Request for Proposal, 19MCO557

In response refer to RFP No. 19MCO557 Addendum 1 and Response to Questions December 27, 2019

Reconstruction of South Fairgrounds Road

MIDLAND COUNTY PRECINCT 2	DA PROJECT B005669.001
S. FAIRGROUNDS ROAD MIDLAND COUNTY, TEXAS	SHEET
ROADWAY PLAN AND PROFILE STA 88+00 TO STA 93+00	24

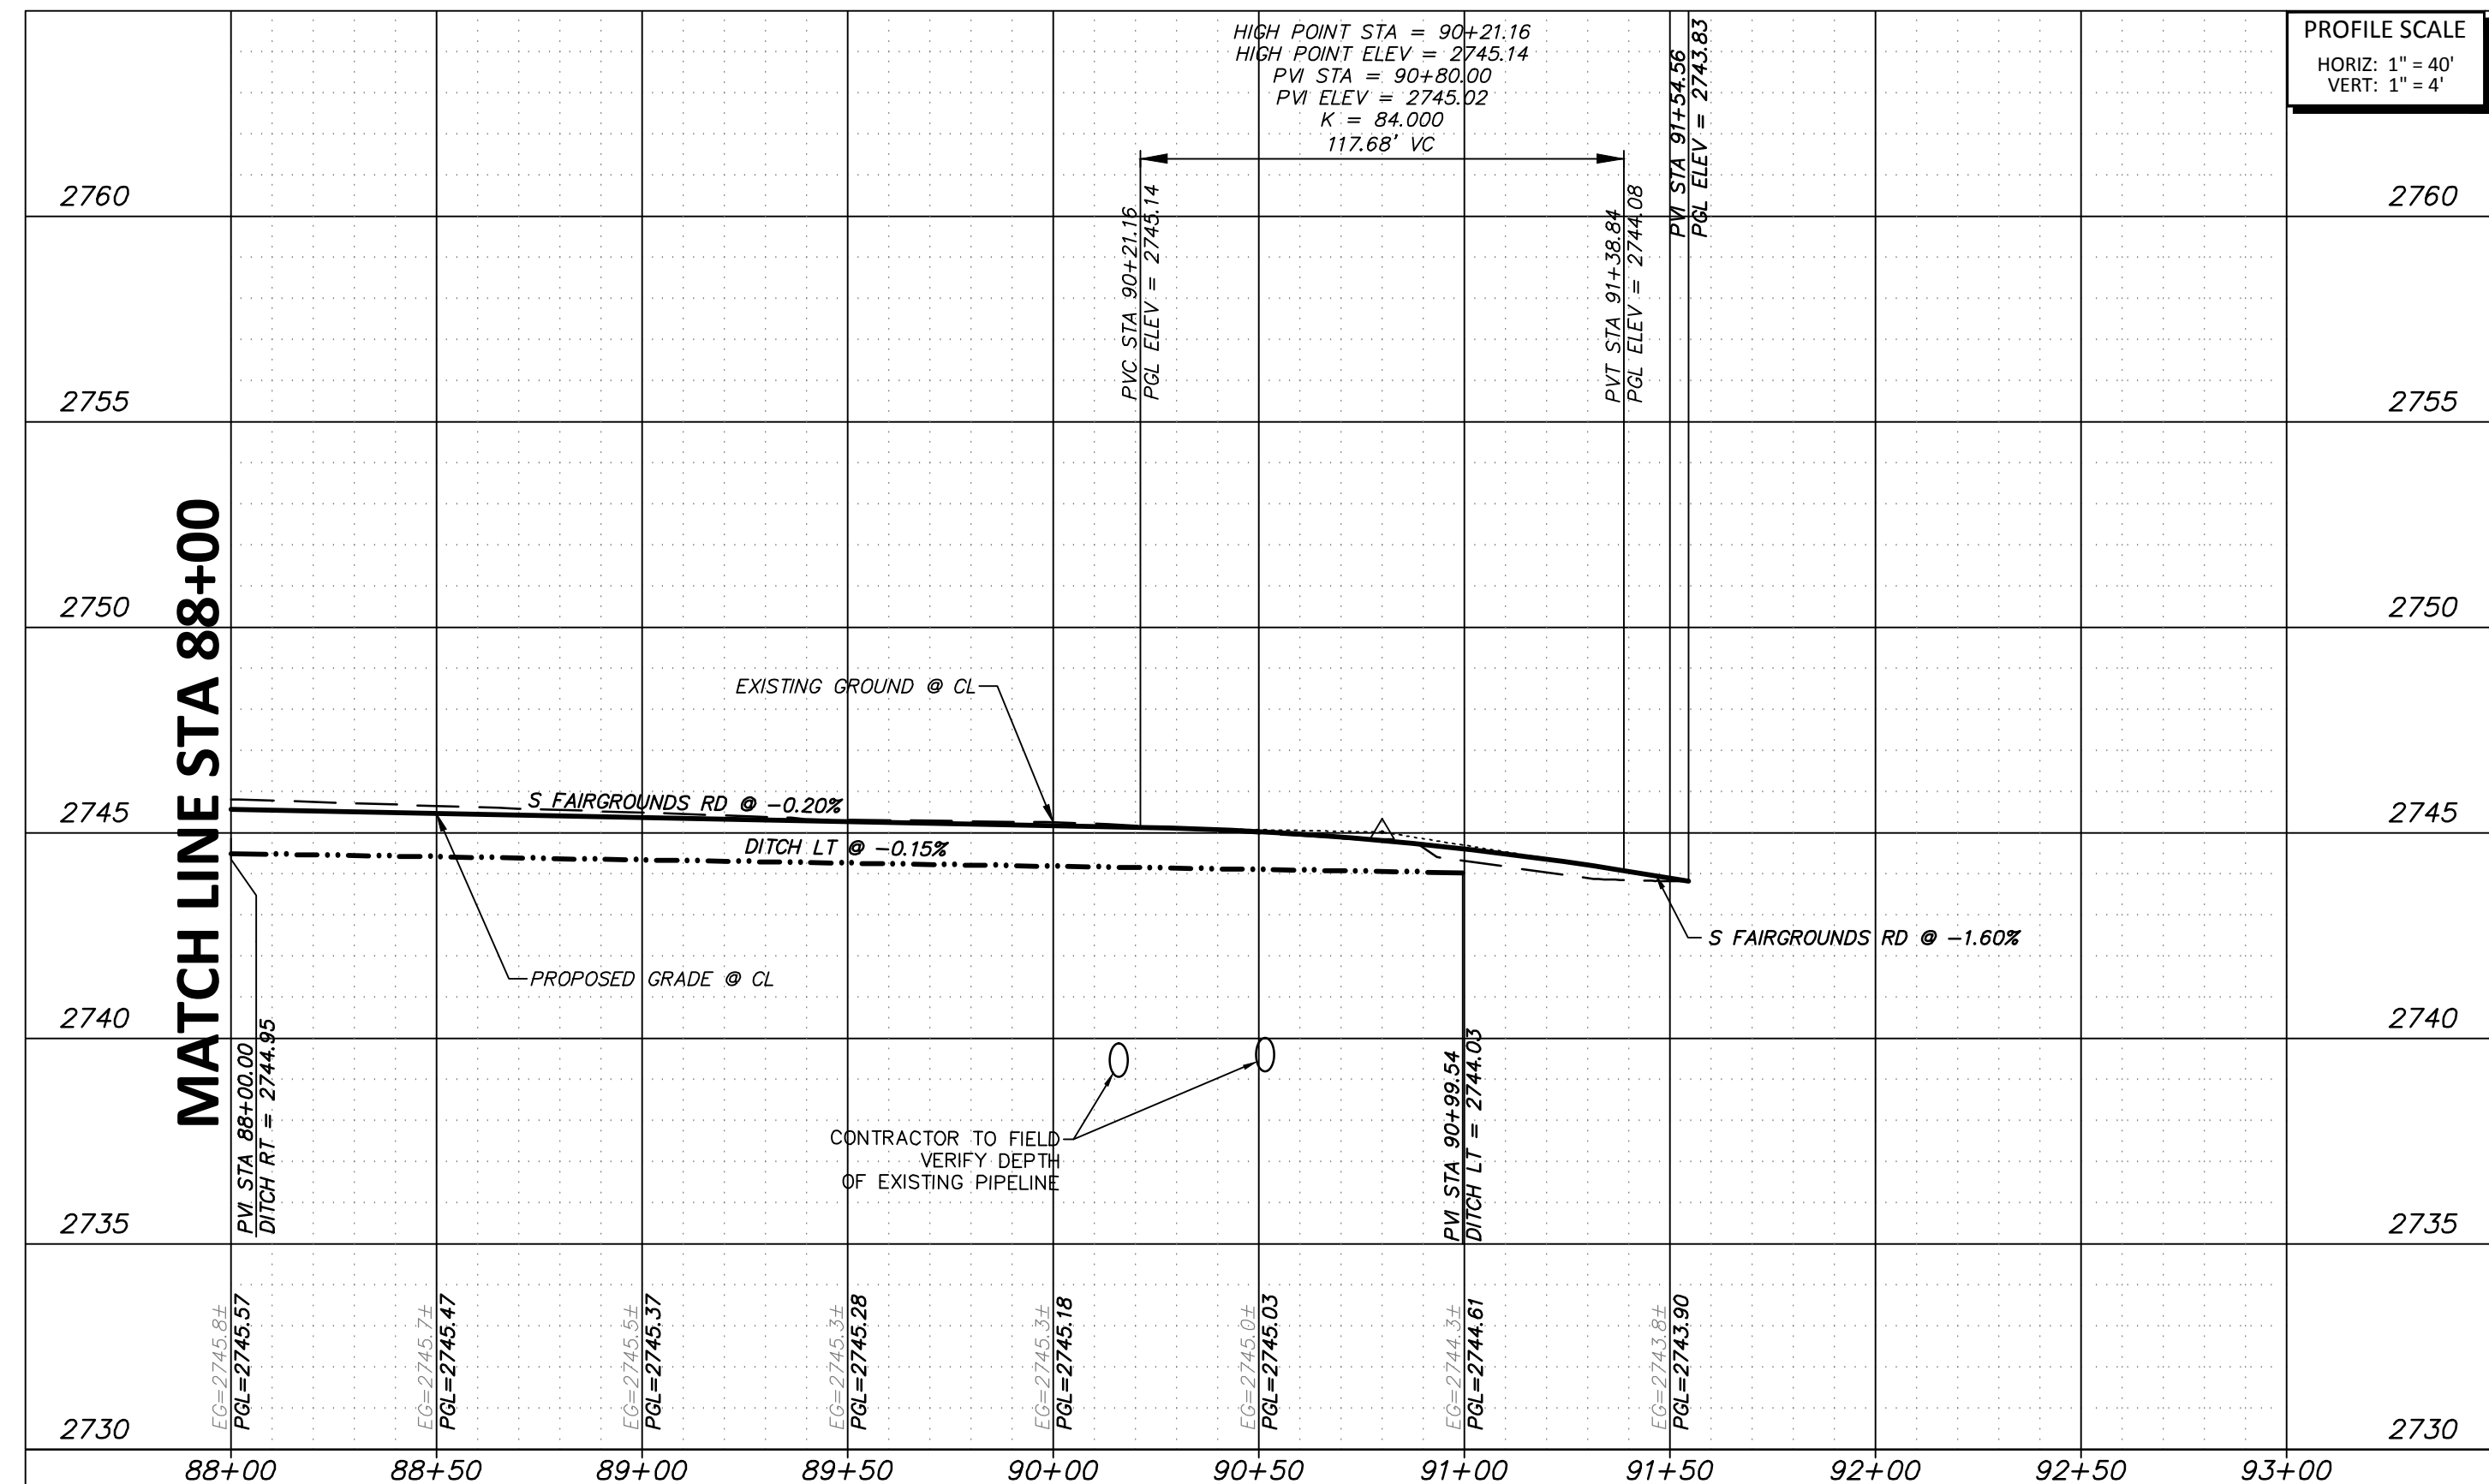
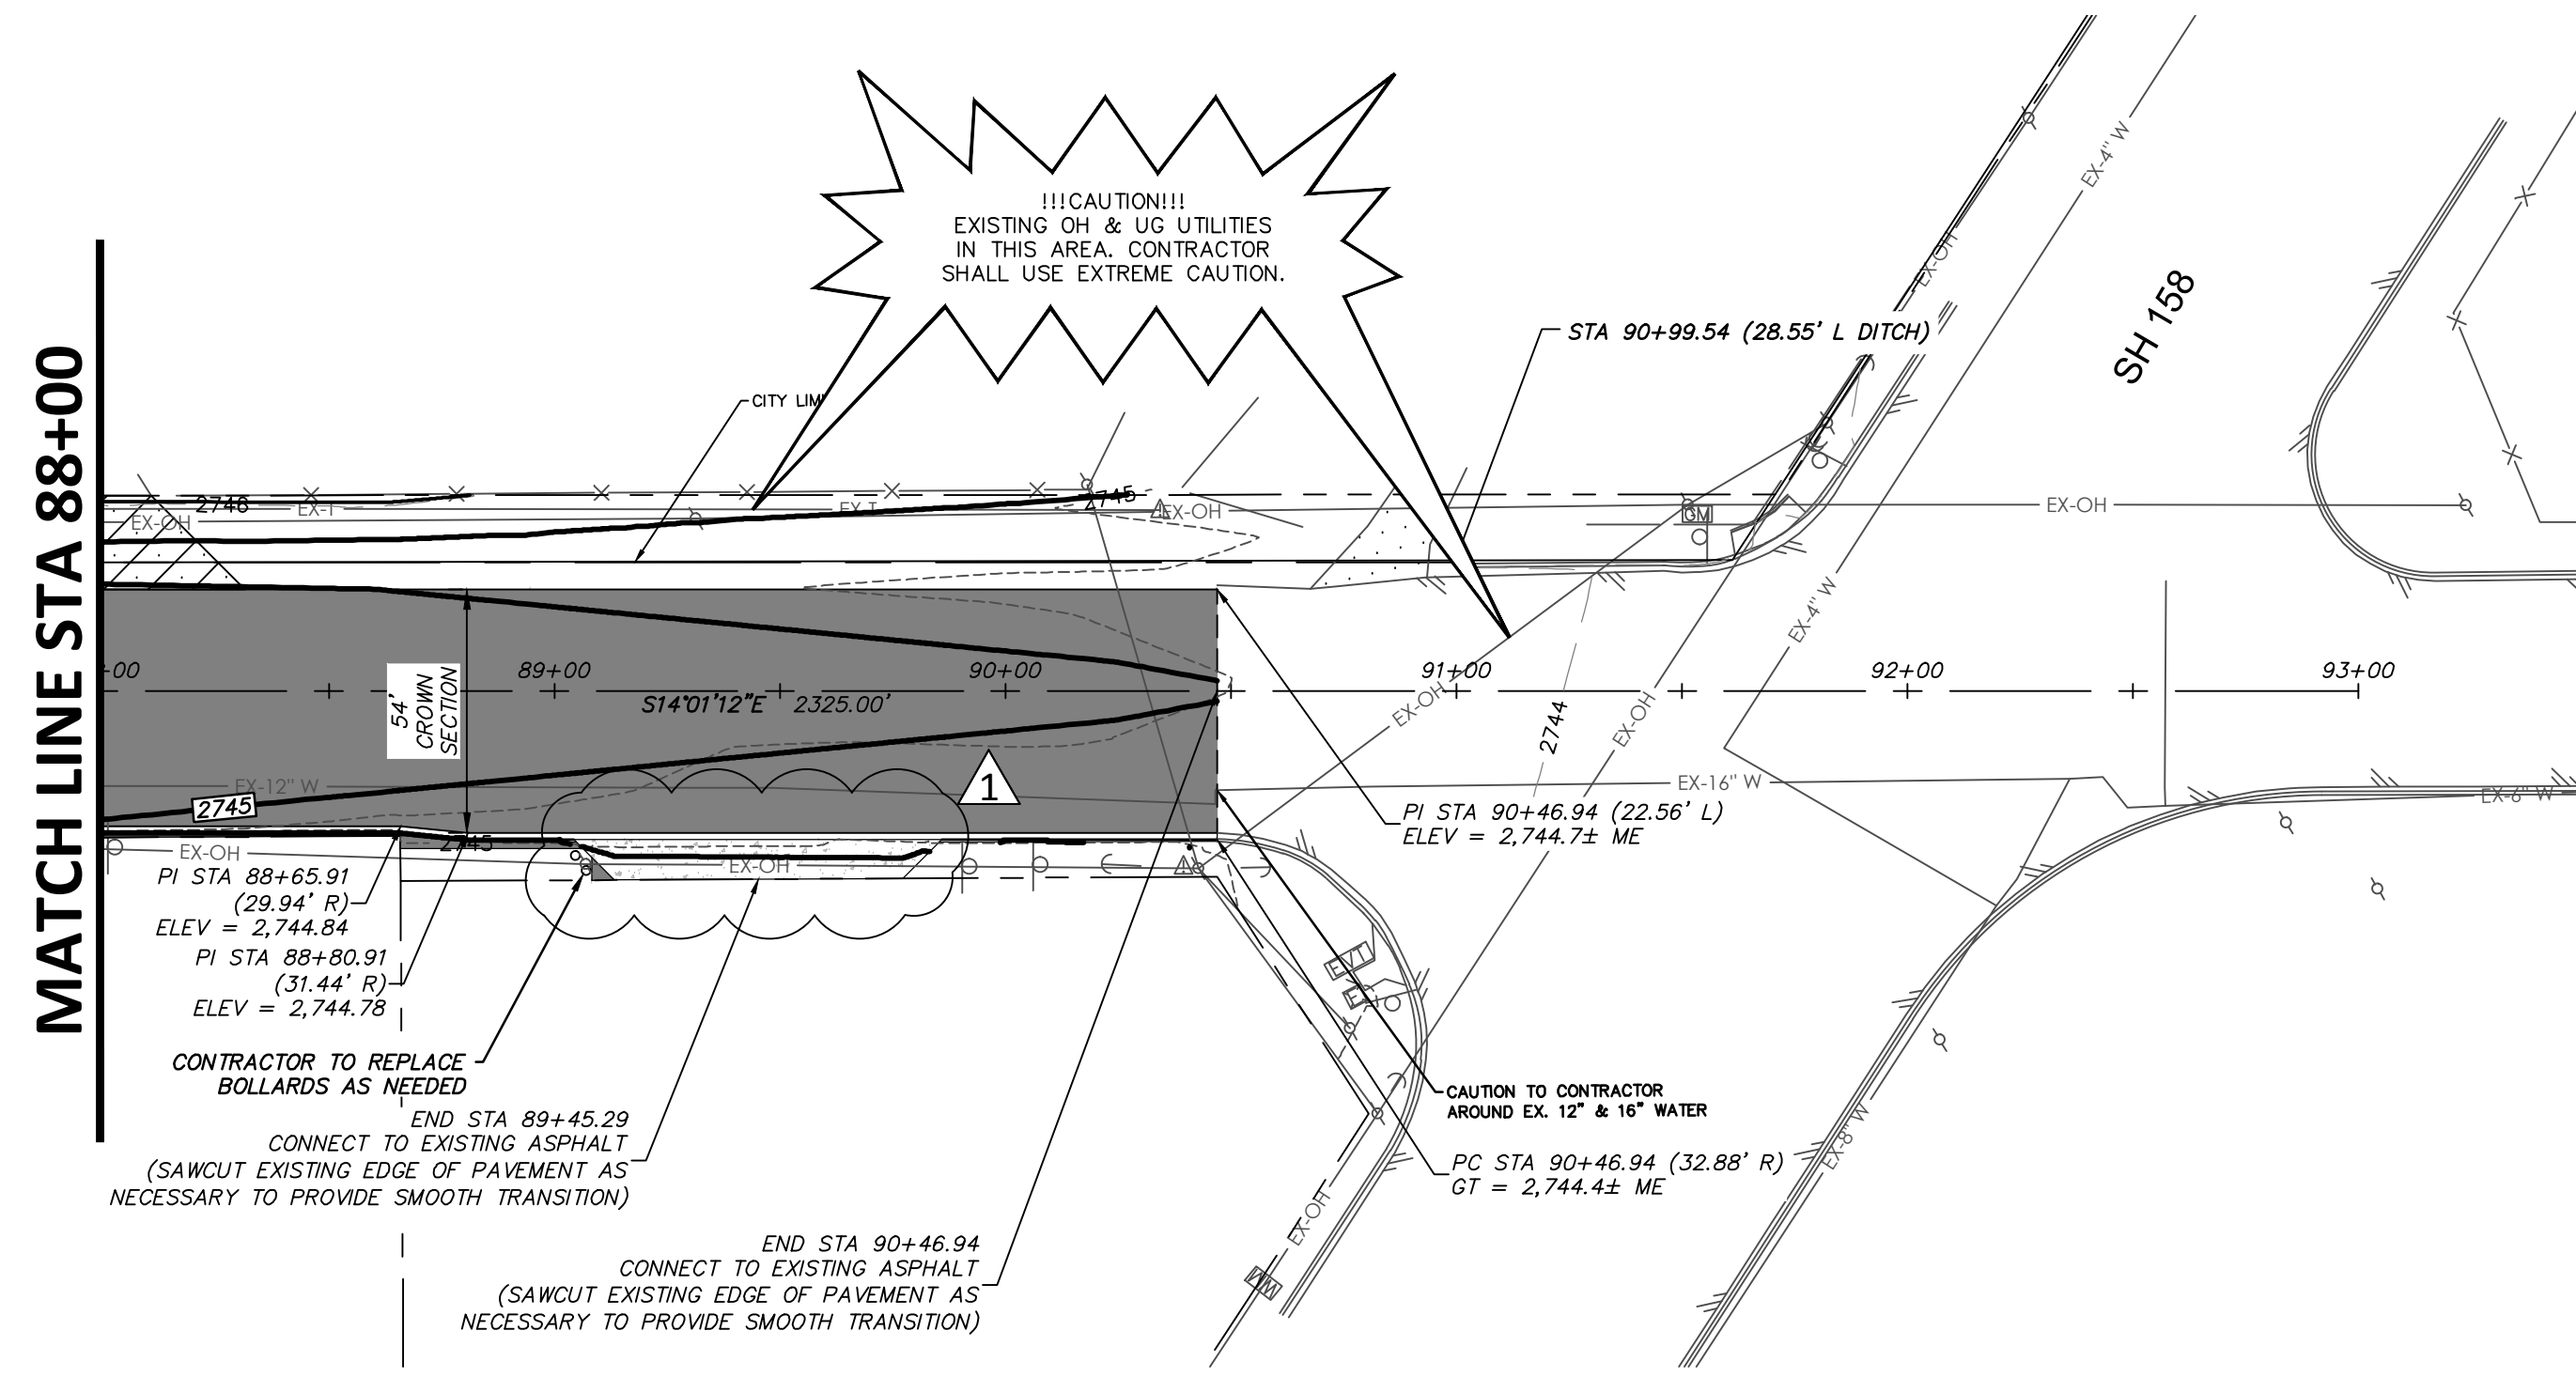
5. There are 5 driveways on the West side of Fairgrounds that are not identified in the legend, 47+80, 55+50, 56+40, 87+50, 89+10. What is required? What is the section?

Please see revised plan and profile sheets issued with these RFI responses.
